CNL-17-100

Clinch River Nuclear Site
NRC Docket No. 52-047

Subject: Response to Request for Additional Information Number 5, Questions 02.05.01-03 and 02.05.01-05, Regarding Basis Geologic and Seismic Information in Support of Early Site Permit Application for Clinch River Nuclear Site

Enclosure 1
Response to NRC RAI Number 5, Question 02.05.01-03

Figure 2.5.1-86 (Sheet 1 of 7) Seismic Tomography Model SRS-1

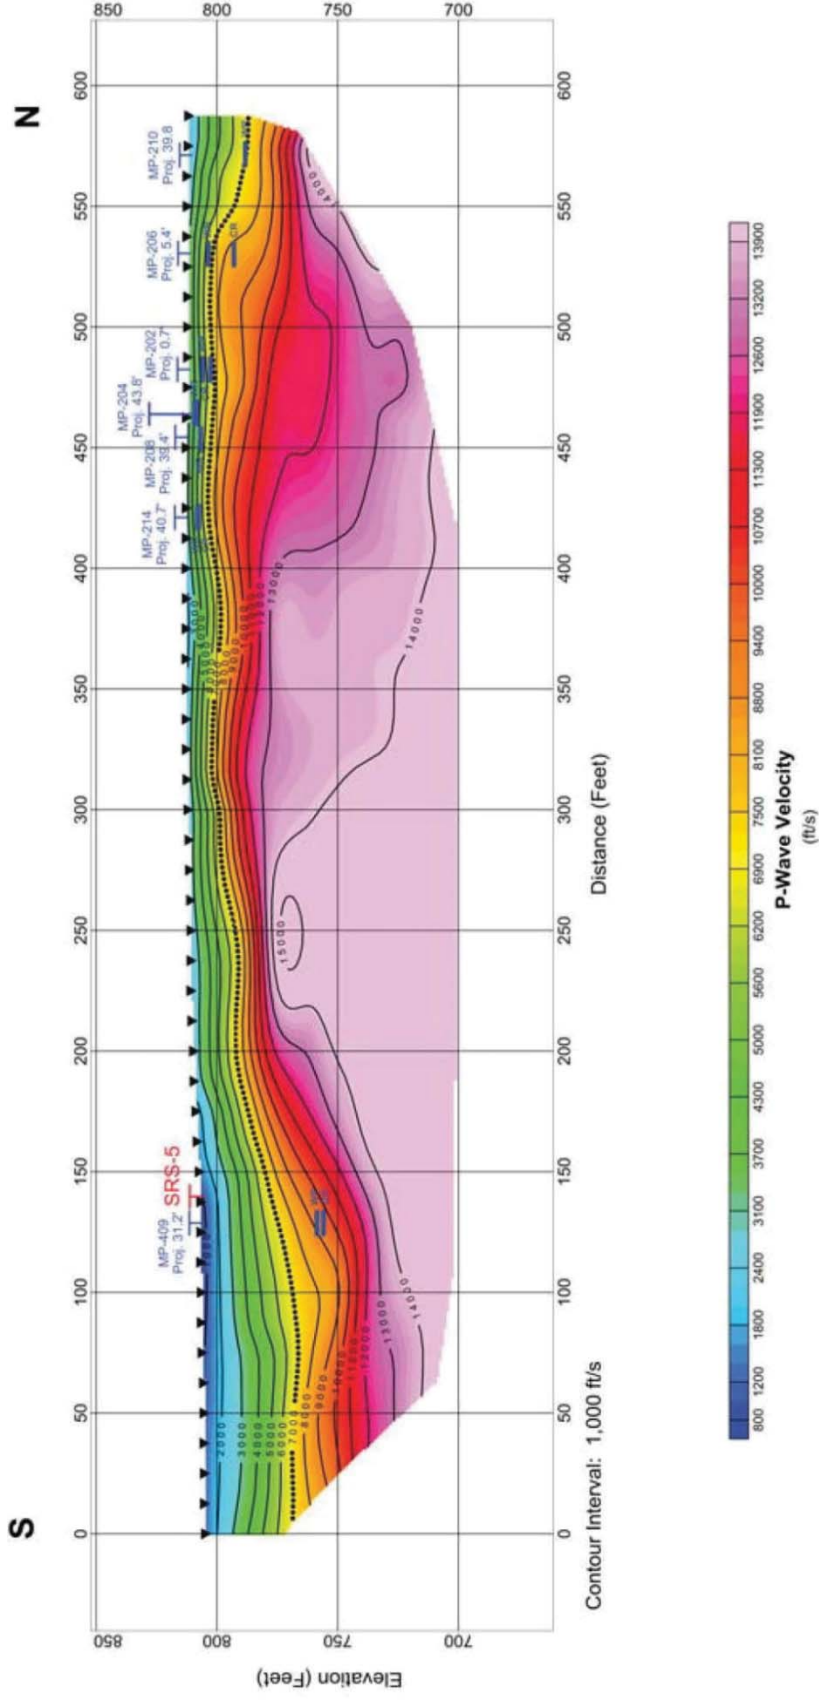
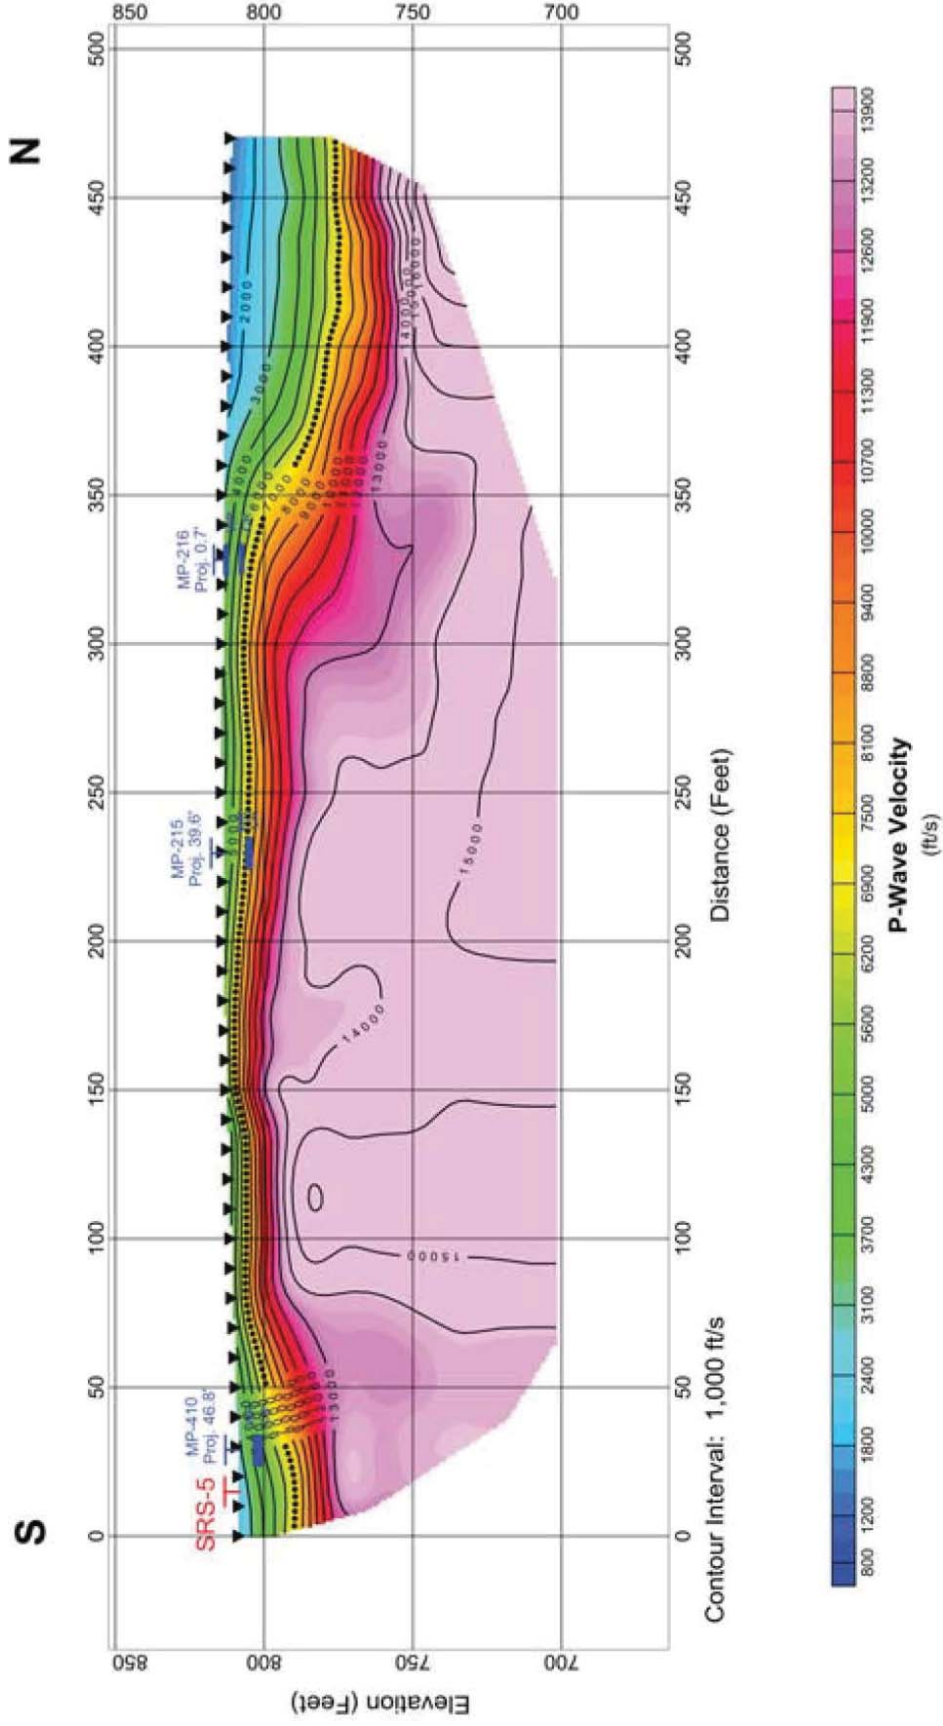
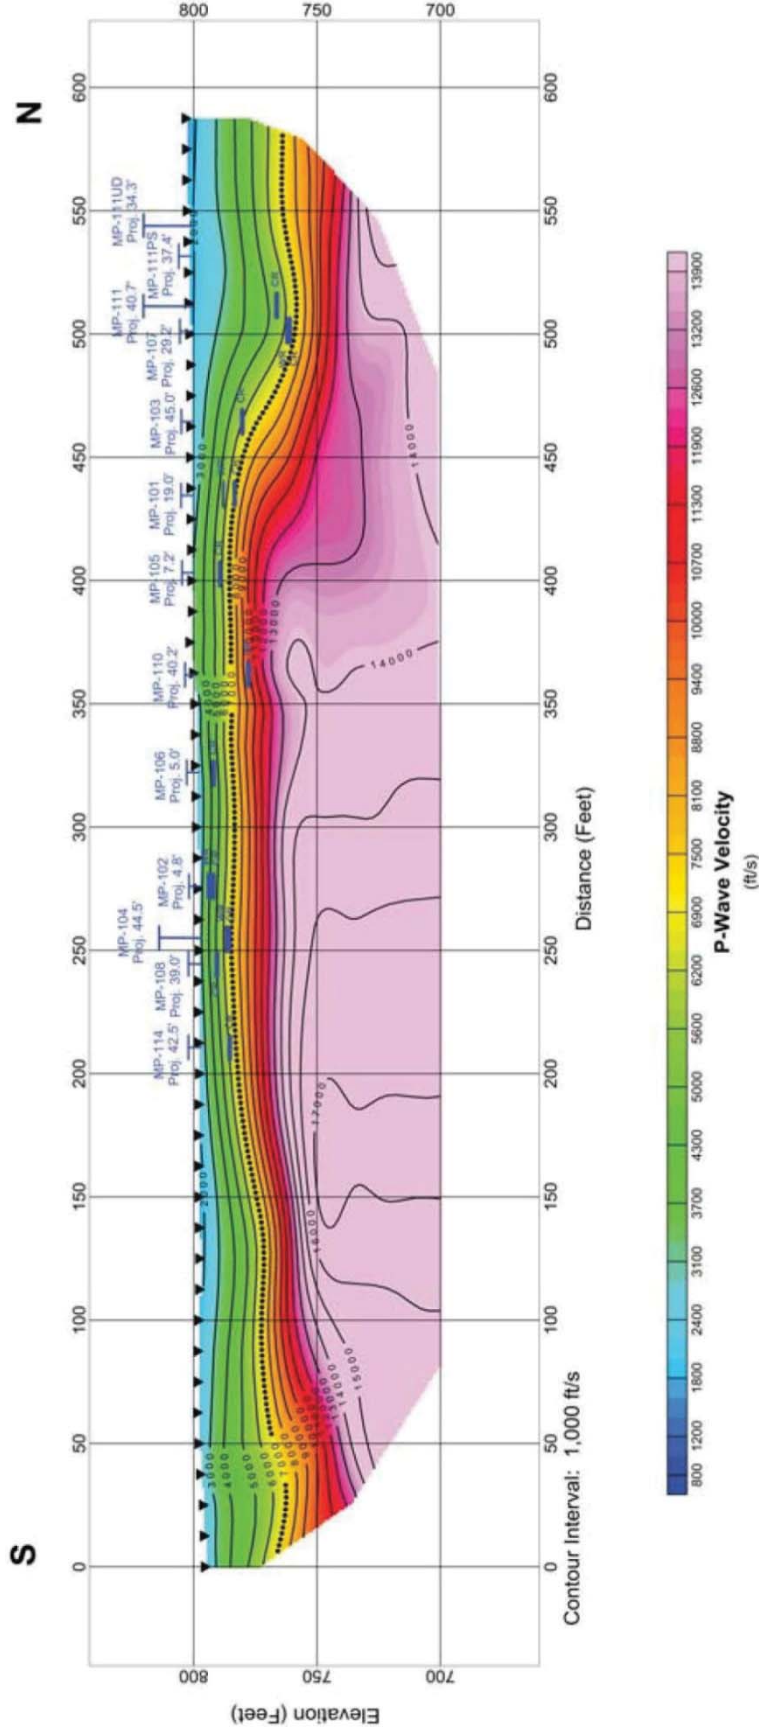
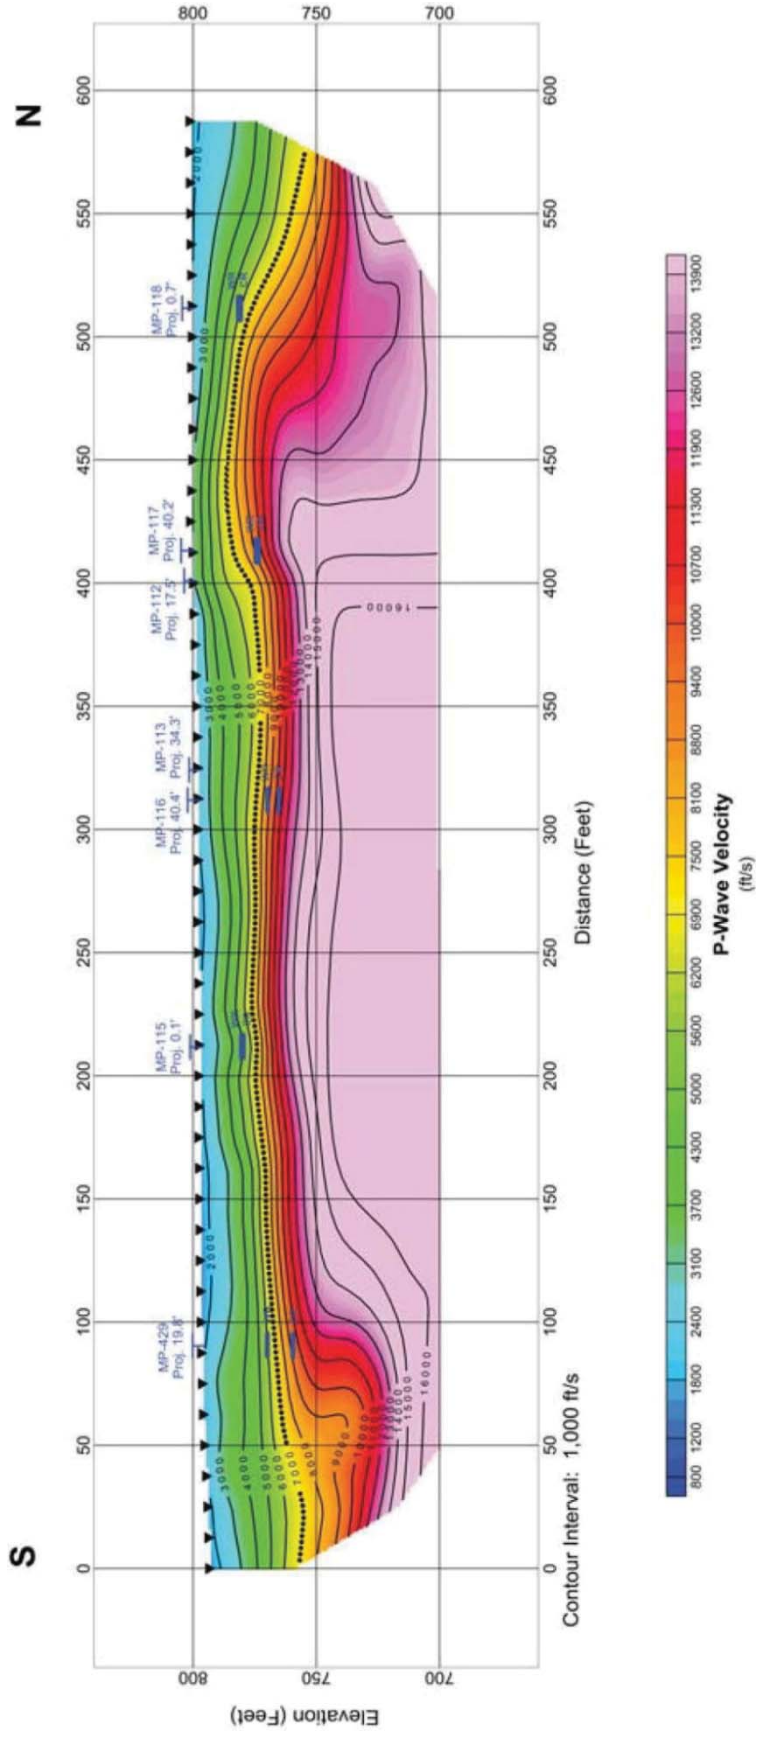
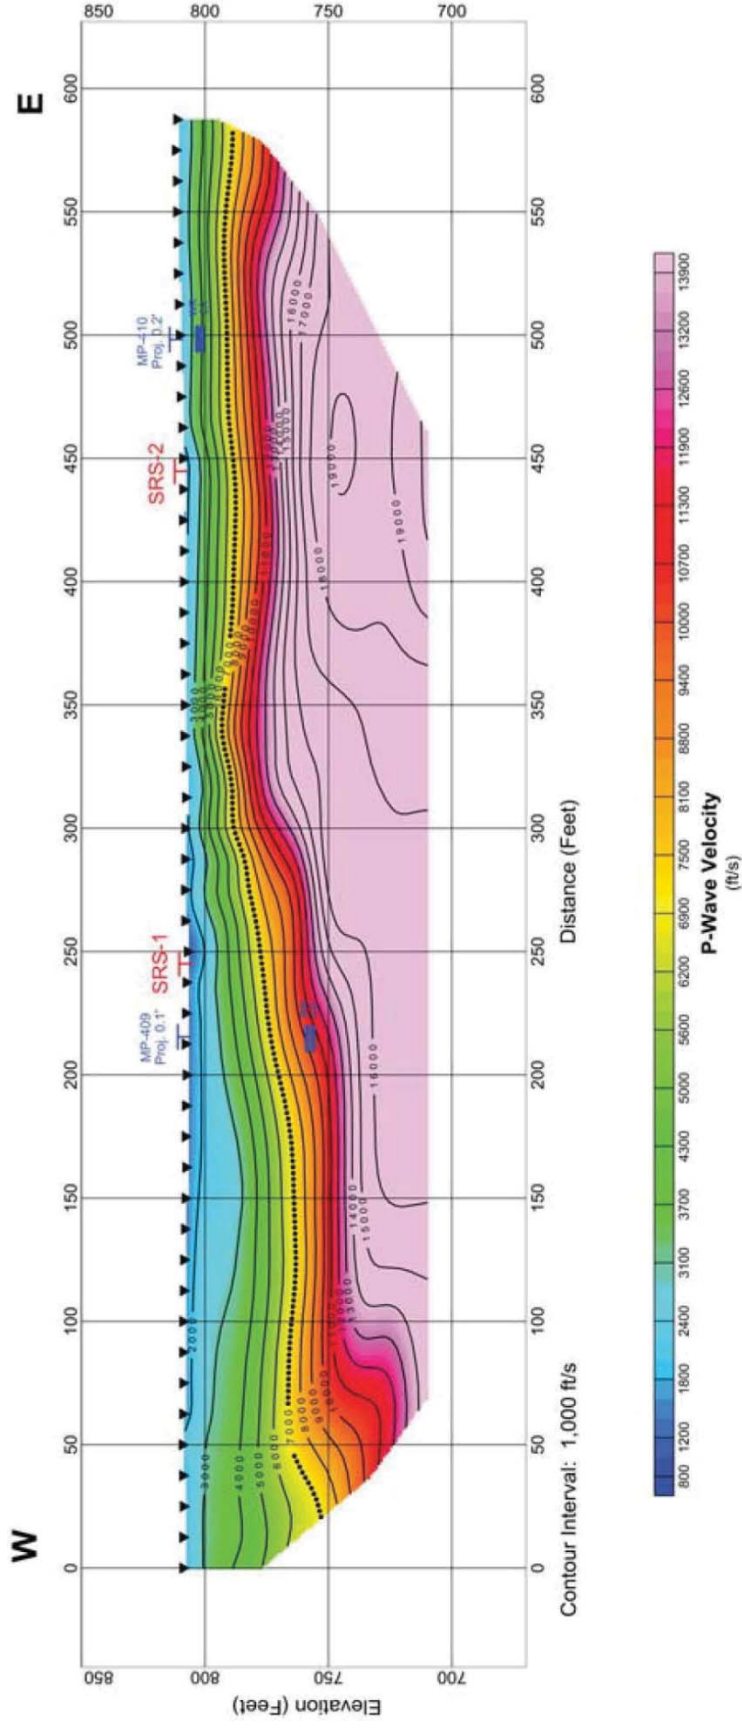
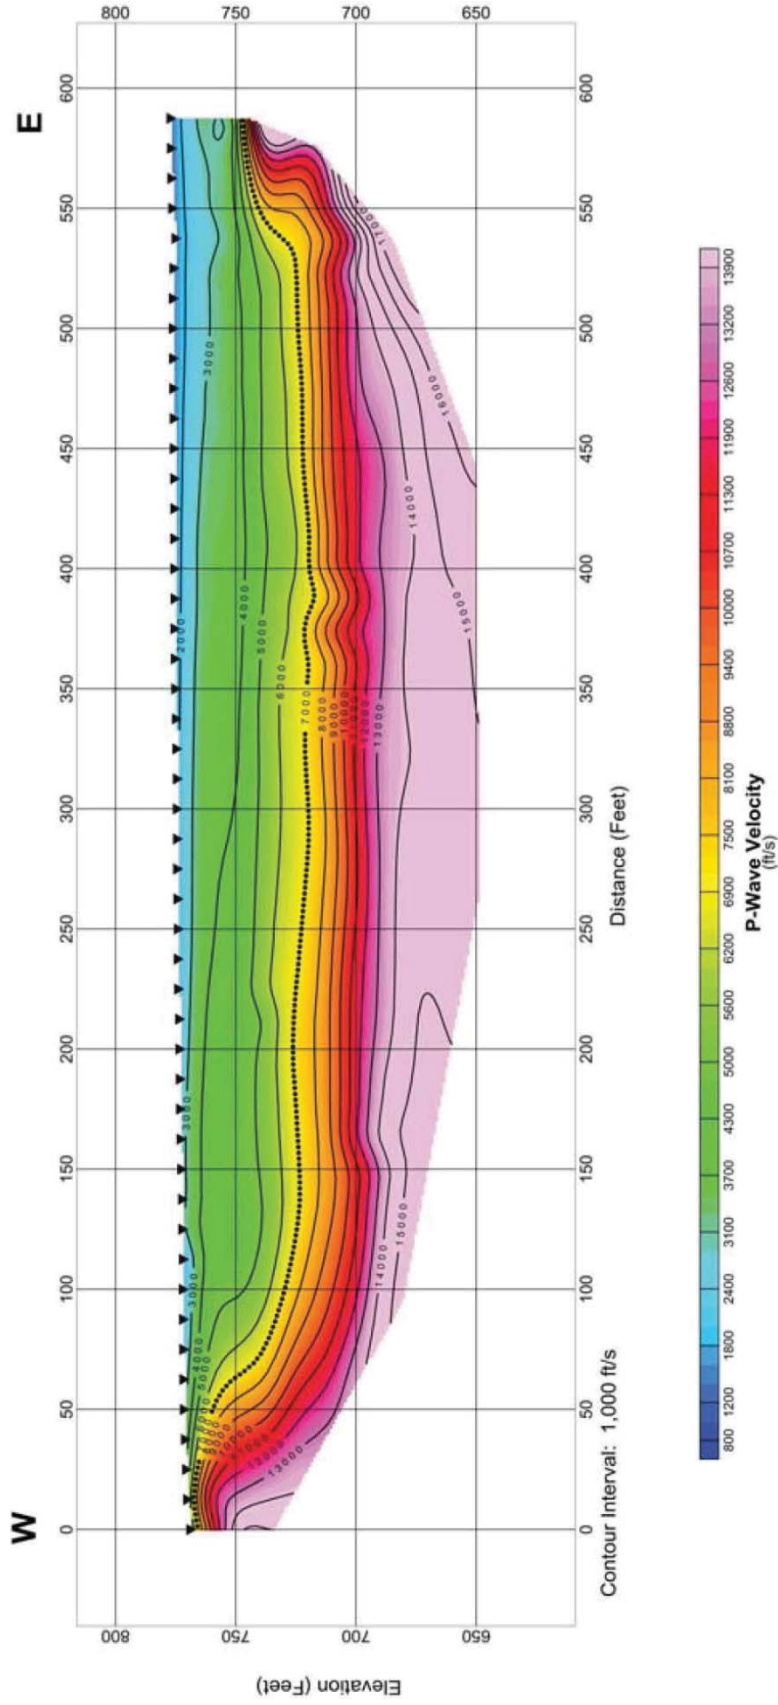
- a. SSAR (Rev 0) 2.5.3.2.3 Karst, indicates that seismic refraction surveys at the site were used to characterize carbonate dissolution features. Because no data were presented in the SSAR (Rev 0) regarding the characterization of the seismic refraction surveys, please discuss the specific evaluation of the seismic refraction data with respect to detecting carbonate dissolution features.*

- a. The primary objective of the seismic refraction surveys was to map the depth to bedrock at the Clinch River Nuclear (CRN) Site, although these data were also reviewed to potentially identify subsurface karst features. As discussed in SSAR Subsection 2.5.1.2.5.1.2, the seismic refraction data are not effective in terms of assessing the presence or absence of karst features, primarily because the lines were collected in areas that had been graded during Clinch River Breeder Reactor Project (CRBRP) activities in the 1970s and 1980s. In some places, significant thicknesses of bedrock had been removed and a thin layer of fill emplaced over the graded bedrock surface. In other places, thick fill had been emplaced to backfill the 1983 excavation or to fill small valleys. The seismic refraction profiles primarily show the extent of fill and depth to bedrock.*

The seismic refraction tomography profiles are being added to the SSAR as figures, and a description of the methods of data collection are being added to SSAR Subsection 2.5.1.2.4.2.1 as indicated in the SSAR markups below. A discussion of the significance of the seismic refraction data to the assessment of karst was previously included in SSAR Subsection 2.5.1.2.1.5.2, and is being revised as indicated in the SSAR markups below to amplify the discussion and refer to the new figures. The SSAR markups will be incorporated in a future revision of the early site permit application.

Six seismic refraction lines were acquired at the CRN Site (Figure 2.5.1-29). The data are presented as seismic tomography models (Figure 2.5.1-86). Such models can be used to resolve complex velocity structure that cannot be imaged using layer-based modelling techniques (Reference 2.5.1-214). The primary objective of the seismic refraction surveys was to map the depth to bedrock in graded and filled areas within the central portion of the site. The data were also reviewed to identify anomalies that might indicate the presence of geologic structures such as blind faults or large karst dissolution features beneath the fill. The resolution of these data is not sufficient to identify small-scale features (less than 10 ft). The results of this review are presented in Subsection 2.5.1.2.5.1.2.

New SSAR Figure 2.5.1-86 is being added to SSAR Subsection 2.5.1:

Figure 2.5.1-87. Crystalline Calcite Deposits Indicating a Hypogene Origin in Caves of Shenandoah Valley, Virginia

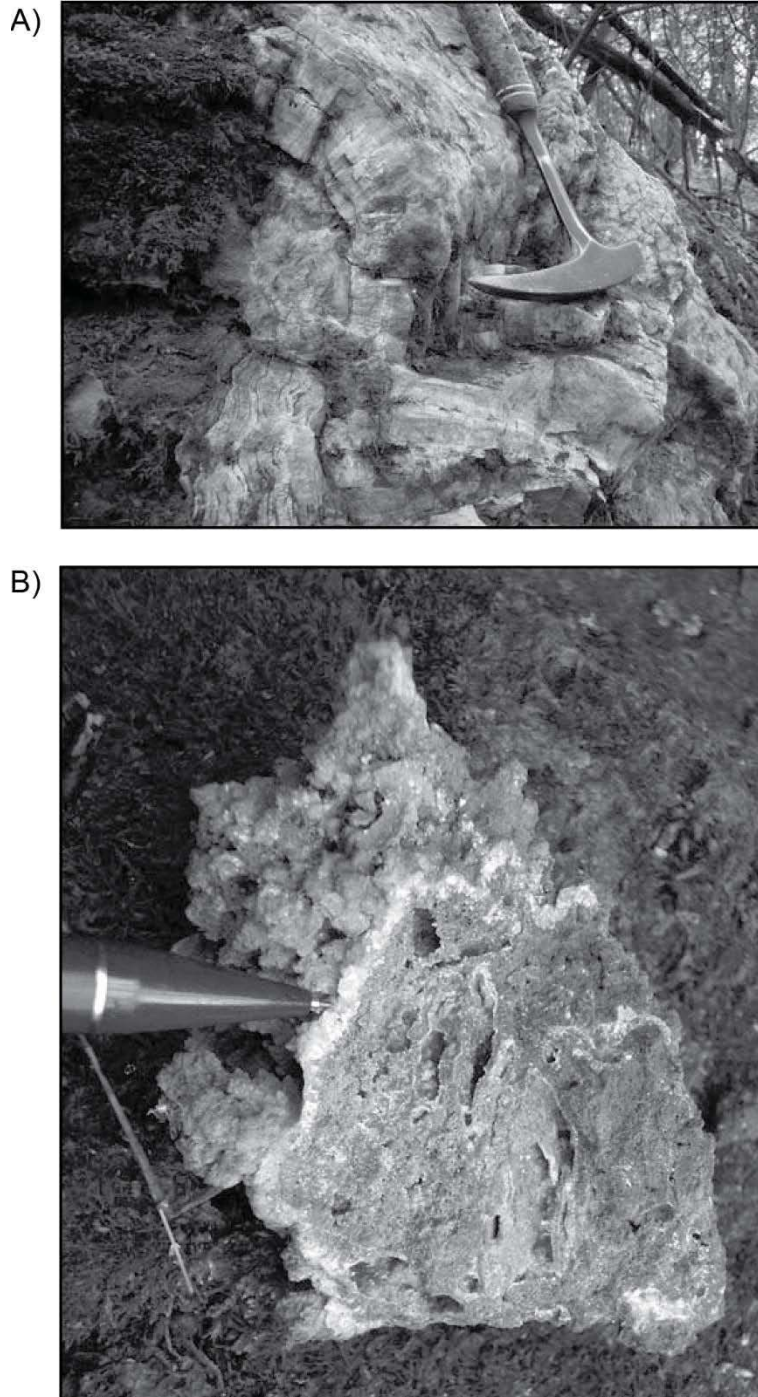
- b. The SSAR (Rev 0) 2.5.1.2.5.1 CRN site karst conceptual model indicates under item 9: "Evidence of hypogene processes is not documented at the CRN Site". The SSAR indicates that some deep phreatic groundwater circulation may be occurring in the Chickamauga carbonate rock beneath the ORR area, and dissolution conduits and cavities may be present to depths of more than 800 ft. (Reference 2.5.1-213, Ausich & Meyer, 1990). Although not discussed in the karst conceptual model, other sections of the SSAR have discussed other possible instances of hypogene karst systems in the area such as: Doll et al, reference 2.5.1-244, 2.5.1-245; TDEC hydrogeologists reference 2.5.1- 299; Nativ and others, reference 2.5.1-300 and 2.5.1-301; Wolf et al., 1997. Please provide a discussion of the potential for hypogene systems or features at the CRN site within TVA's conceptual model which also includes relevant information from these citations.*

The major lines of evidence Doctor and Orndorff present for hypogene dissolution and deep phreatic dissolution of caves in the AGV are (1) the random landscape position of the caves, (2) the complex geometry of cave passages, (3) the presence of many thermal and travertine springs, and (4) the observation of cavities in water wells to depths of more than 1,000 ft. Caves appear to be randomly distributed beneath the landscape without regard for the modern stream networks. Cave elevations do not cluster about stream terrace elevations, nor do they cluster at any elevation that might reflect pauses in regional downcutting. Passages are not related to positions of modern trunk streams. Instead, cave passages are maze-like with vertical extents of over 20 m (76 ft). They follow joints, faults, and bedding planes, and have phreatic features such as cupolas and feeder tubes. Caves are known to occur in isolated hills with no inlets or outlets, far from base level streams. In an interview (Reference 2.5.1-298) and publication (Reference 2.5.1-319), Doctor also noted the presence of exotic mineral deposits, including dog-tooth spar, gypsum, iron, or fluorite, as evidence of hypogene processes (Figure 2.5.1-87). Present-day thermal and travertine springs indicate that hypogene conditions likely still exist at depth, and the presence of very deep dissolution cavities in water wells supports hypogene dissolution as an ongoing process. Figure 2.5.1-71 shows Doctor and Orndorff’s (Reference 2.5.1-296) model of how the interaction of a fault and a fold can result in hypogene dissolution by waters rising along a fault.

New SSAR Figure 2.5.1-87 is added to SSAR Subsection 2.5.1:
